**GOVERNMENT OF PUERTO RICO  
PUBLIC SERVICE REGULATORY BOARD  
PUERTO RICO ENERGY BUREAU**

**CASE NO.:** CEPR-AP-2018-0001

**SUBJECT:** Final Resolution and Order on  
the Puerto Rico Electric Power Authority's  
Integrated Resource Plan.

**FINAL RESOLUTION AND ORDER**  
**ON THE PUERTO RICO ELECTRIC POWER AUTHORITY'S**  
**INTEGRATED RESOURCE PLAN**

**Figure 1. PREPA Planning Reserve Margin With Existing Resources and Forecast Peak Load, 2019-2038**

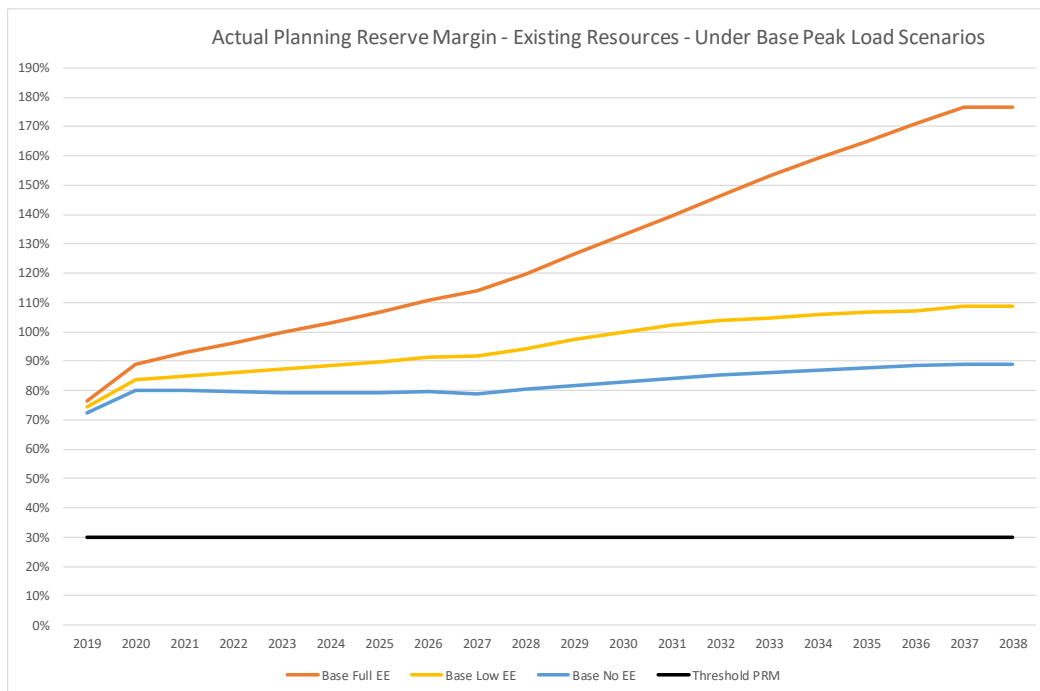
343. As seen, the electric power system’s overall PRMs in all three baseload cases (*i.e.*, baseload forecast with three different levels of applied EE) remain high, when counting all of the existing capacity and prior to considering availability and potential retirement, closure, or contract cessation for some resources.<sup>349</sup> For the baseload projection with full EE, the PRM steadily increases, to well over 100% and reaching 160% by 2034. The highest load forecast, with no incremental EE, leads to reserve margins of 89% at the end of the period.

**Figure 2. Planning Reserve Margins Under Limited Availability of Certain Existing Resources**

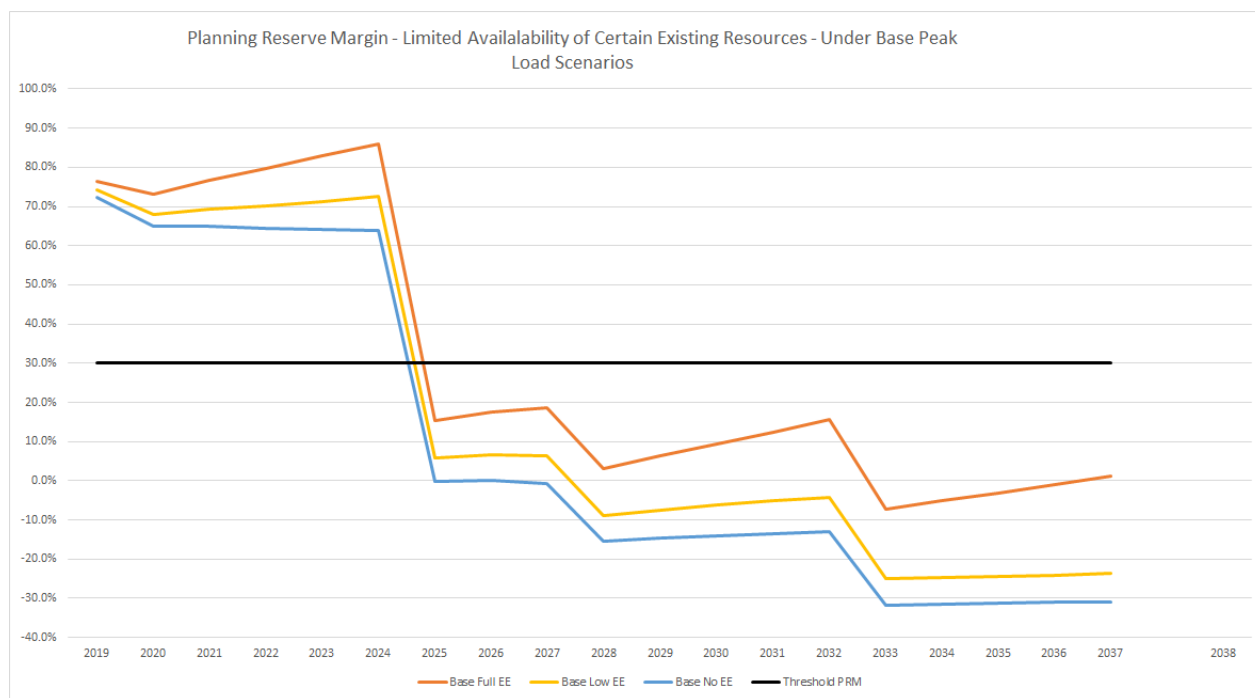
345. Figure 2 below illustrates PRMs on the system assuming that: (i) all MATS-impacted units retire by the end of 2024 (Aguirre 1&2, Palo Seco 3&4, San Juan 7&8); (ii) Aguirre CC units 1 & 2 retire by the end of 2024; (iii) that roughly half of the older GT units are not available as of 2020; and (iv) that Costa Sur 5&6 are returned to service, AES closes at the end of 2027, and the EcoEléctrica contract is not renewed after 2032.<sup>351</sup>

**Figure 3. PREPA Annual Net Position, MW, Existing Resource Base with Projected Closures, Retirements, and Reduced Availability**

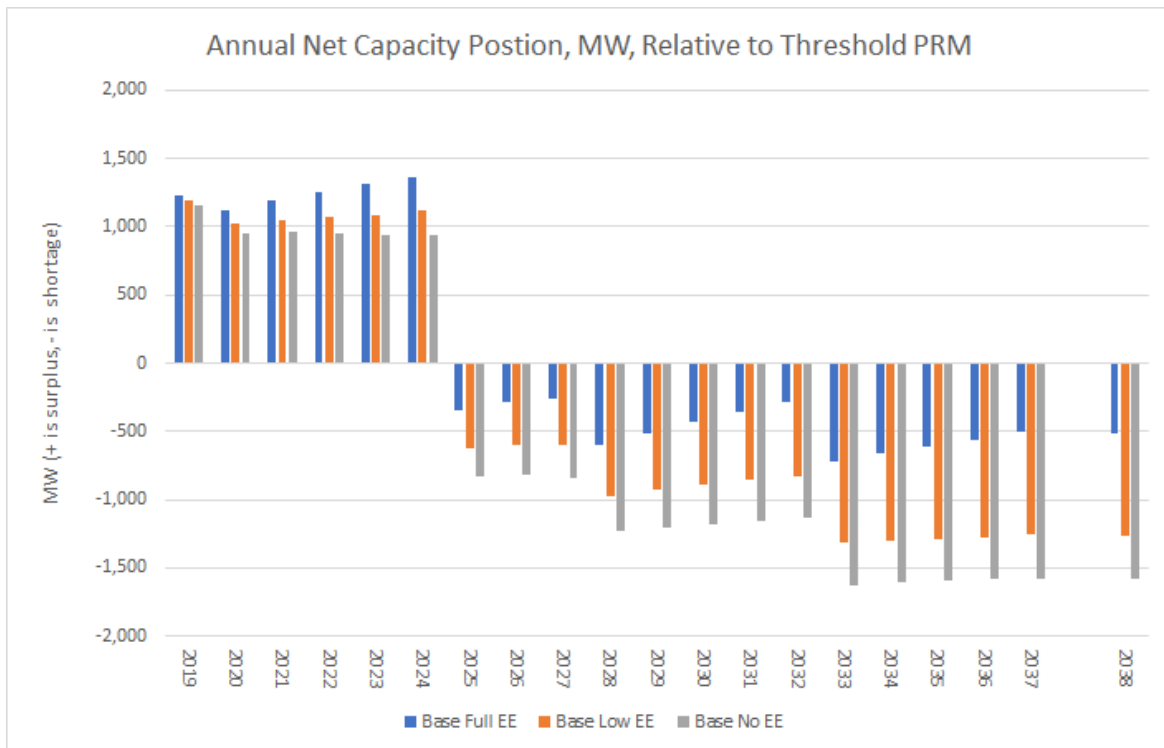
348. Figure 3 above illustrates the range of capacity need PREPA faces given its load forecast outlook, and its existing resource base. The following observations can be made:

**Figure 4. Annual Net Position with S4S2 Level of Battery Additions**

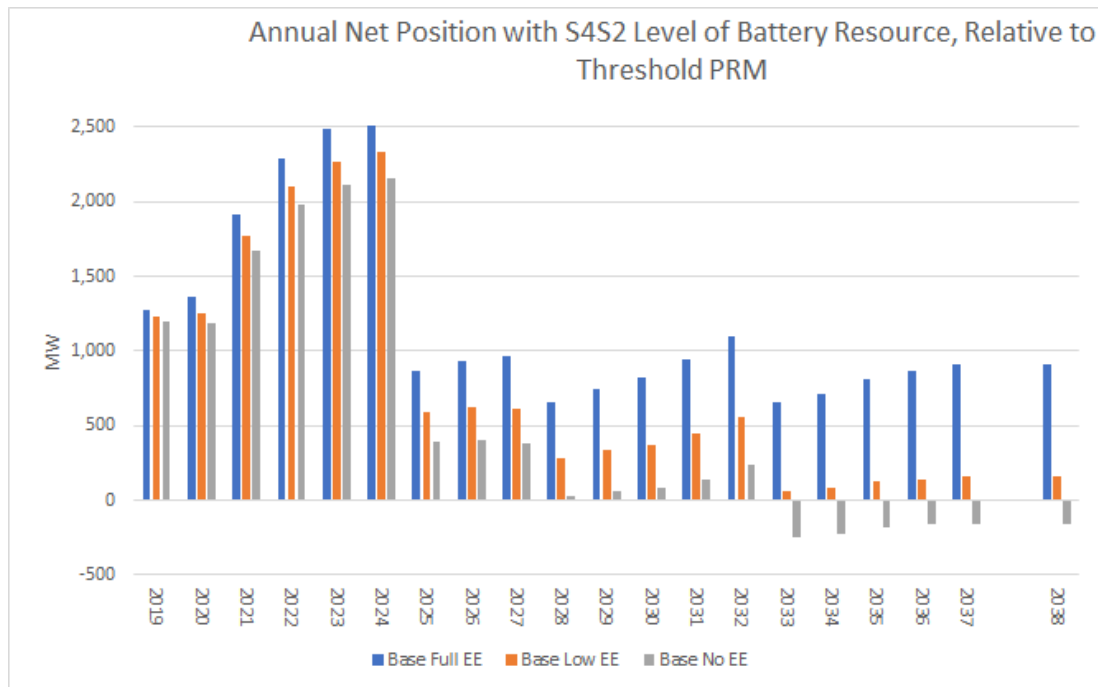
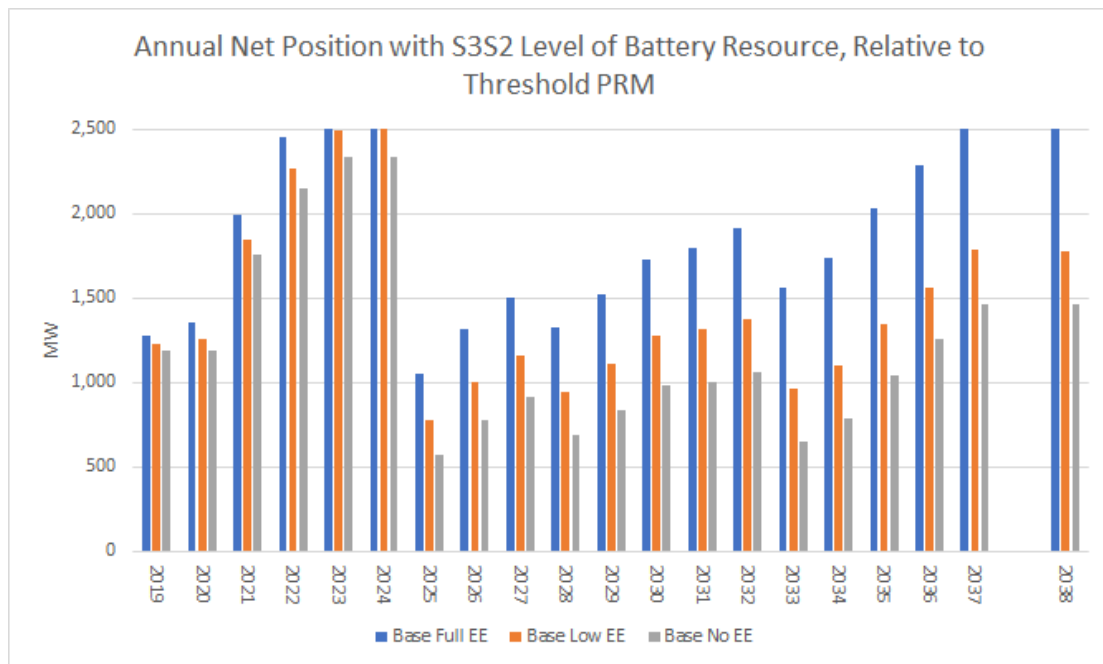
351. Figure 4 and Figure 5 above illustrate that batteries alone, without new fossil-fired capacity, could allow minimum PRM capacity needs to be met as MATS-impacted units retire, and assuming Costa Sur 5&6 remain in service (with any retirement or closure of return to service of either or both Costa Sur units, for the year or years in which they might retire, the “headroom” above minimum requirements is decreased). Higher levels of EE, as seen in the “Base Full EE” columns above, allow for the minimum reserve margin to be met with lower levels of battery installation because the peak load in Base Full EE scenarios is lower than in the other Base Low EE and Base No EE scenarios. Figure 5 also illustrates the importance of higher levels of peak load reduction from EE, and the presence of more battery capacity, in the later years when capacity from AES and EcoEléctrica may not be available. Figure 4 and Figure 5 show that with No EE or Low EE, 2025 and 2026 are critical years in the early portion of the planning period, when PRMs are at their lowest.

352. The PRM is high when counting all of the existing capacity but is much lower when both Costa Sur 5&6 and MATS-affected resources are unavailable, and when capacity is lost with AES and EcoEléctrica contract cessation, as seen in Figure 4 and Figure 5 above. This outcome indicates that increasing headroom (beyond minimum requirements) for economic retirement of MATS-impacted units will occur only after capacity installations.<sup>355</sup> Capacity installations are represented by the battery resources chosen in S4S2 and S3S2 and seen in Figure 4 and Figure 5.

353. This analysis further indicates that new gas-fired peaker replacements are not necessarily required for PRM purposes. This outcome assumes that: if it is assumed that battery resources of a similar scale as required in PREPA’s scenarios will be installed – first - in accordance with the early-year timelines in those scenarios; and that the capacity at Costa Sur 5&6 remains at least until such battery resource installations allow PREPA’s annual net position to be higher than the Costa Sur units’ output, which is seen in Figure 5 as occurring as early as 2025, provided that peak reductions from “full” EE resources are captured. The exception to this finding, that gas-fired resources are not needed, exists only if one abides by PREPA’s definition of capacity need under the proposed MiniGrid construct. That construct imposes effectively higher PRMs on the system and directly states that “thermal” or fossil-fired resources are required.<sup>356</sup>

Figure 6. Henry Hub Forecast: PREPA, AEO 2018, and AEO 2020 (\$/MMBtu nominal)

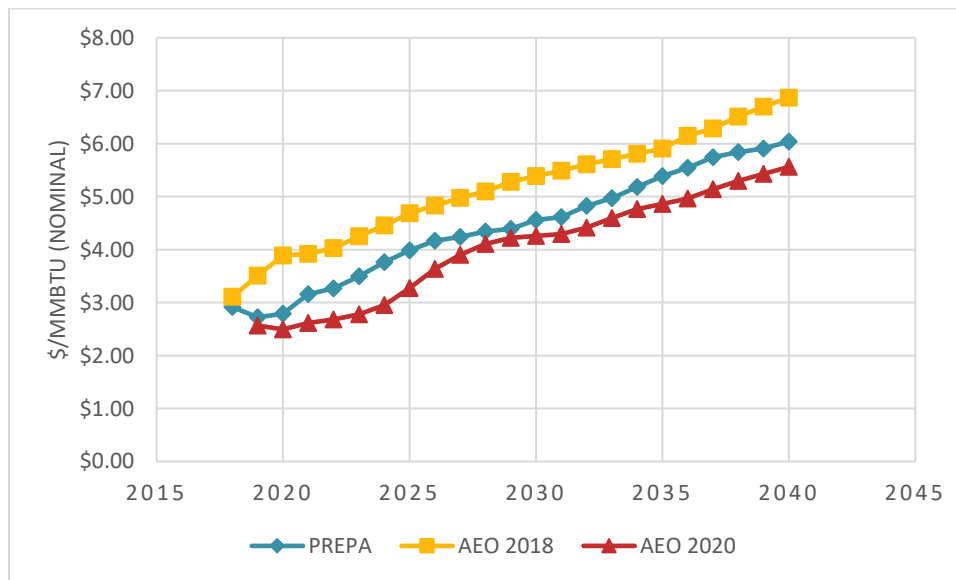
541. In the Proposed IRP, PREPA noted that the forwards were used for the first 18 months of the Proposed IRP period and then blended with its longer-term forecast for the next 18 months.<sup>702</sup> PREPA's longer term natural gas forecast was lower than the AEO 2018 forecast. In January 2020, EIA released AEO 2020, which contained an updated natural gas forecast but does not account for the current impacts of the COVID-19 pandemic.<sup>703</sup> The following graph compares PREPA's Proposed IRP forecast with AEO 2018 and AEO 2020.

**Figure 7. WTI Forecast: PREPA, AEO 2018, AEO 2020, and STEO June 2020 (\$/barrel nominal)**

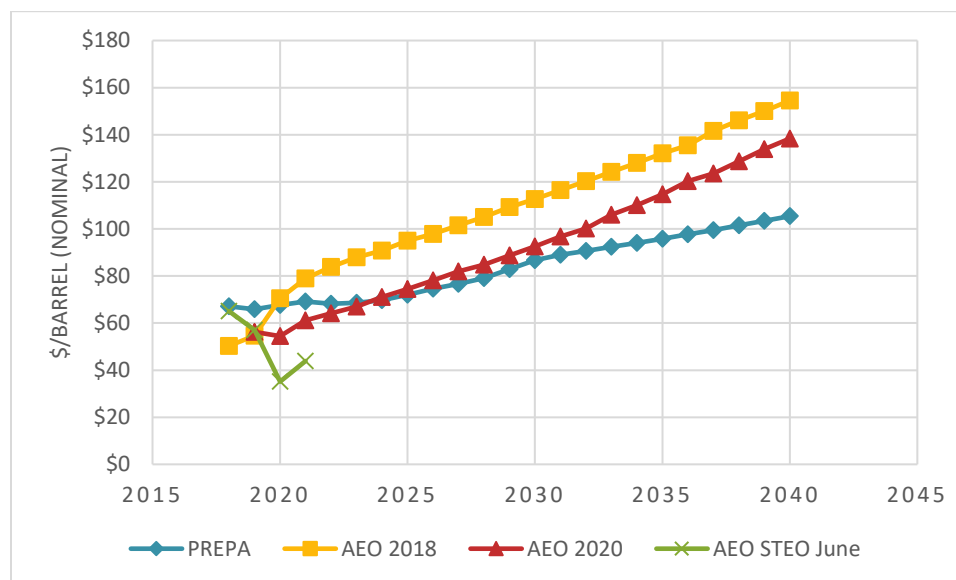
impacts of the COVID-19 pandemic.<sup>708</sup> The EIA publishes a short-term energy outlook (STEO) that does reflect some impacts of COVID-19 on supply and demand.<sup>709</sup> The following graph compares PREPA's Proposed IRP forecast with AEO 2018, AEO 2020, and STEO (June).
